Division 2 Clarifications by Division

FIREHOUSE APARTMENTS
Bristol, Vermont

95%
CONSTRUCTION

PROPOSED SITE PLAN

C-1.2

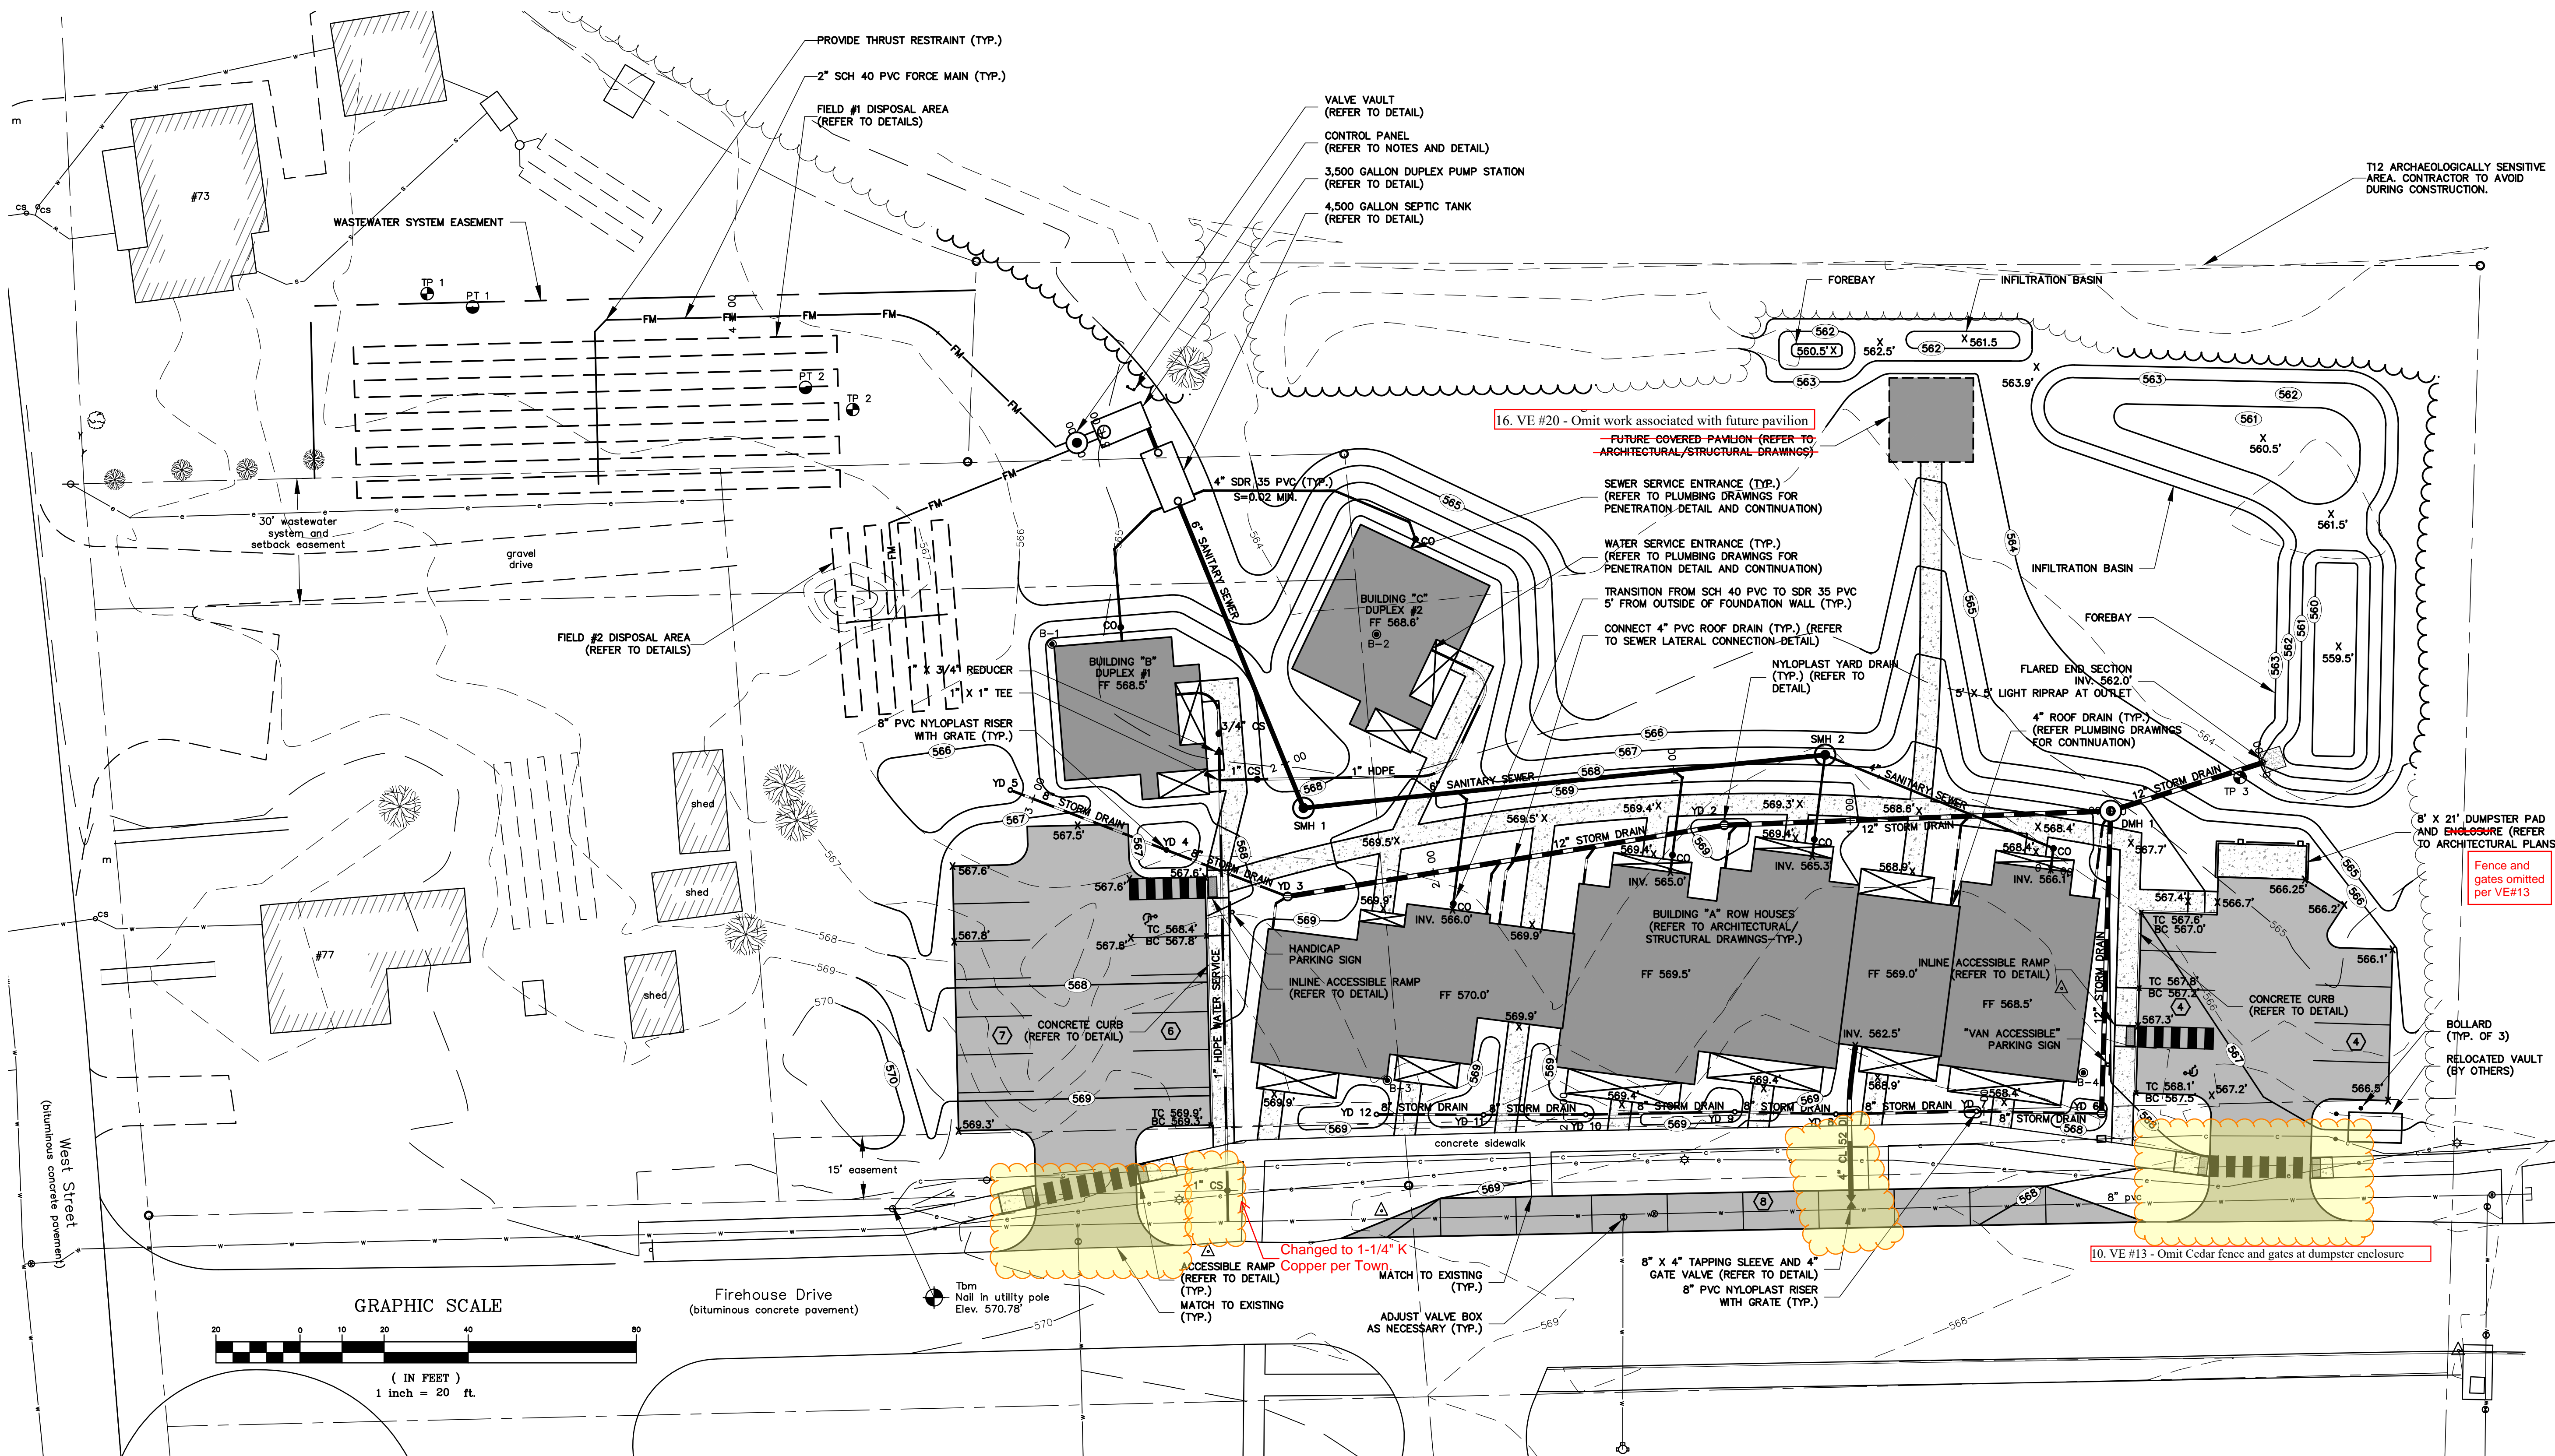
1. We have carried monies associated with site prep for the gazebo, but no monies for the gazebo itself. Civil drawings note to refer to structural and Architectural drawings, however, nothing is mentioned in the drawings or specifications for this scope.
2. We have priced the site work such that all topsoil can be stripped and stockpiled on site, per the soil amendment notes, and can be re-used after, except for new topsoil at the wastewater disposal area
3. Please note that current lead times on ductile iron pipe of 6" to 12" in diameter are 24-28 weeks, after order.

3. VE #3 - Consider Paved Walks ILO Concrete
4. VE #4 - Consider gravel drive ILO Paved
5. VE #4a - Reduce Subbase at Parking and Roads (25%)
